RISO, INC. **PARTS CHANGE INFORMATION**

PART: GUIDE SPRING B; DISPOSAL BOX **ISSUE #: 035**

JAPAN: RC0068

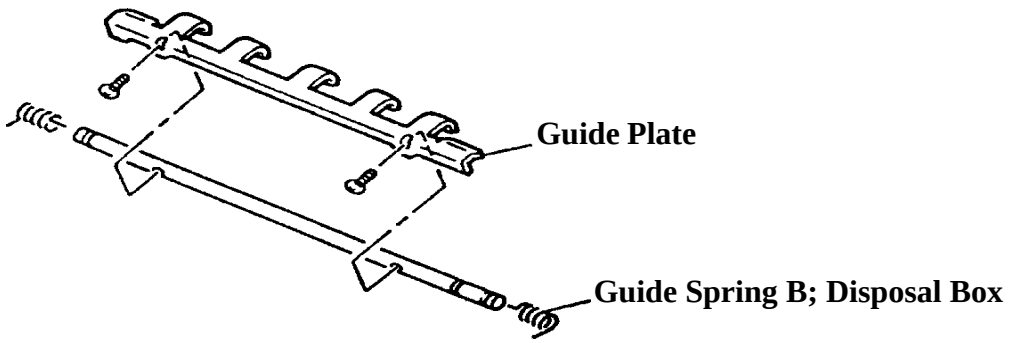
To ensure the Guide Plate hooks firmly onto the Vertical Transport Roller (Down) - Guide Spring ”B” has been added.
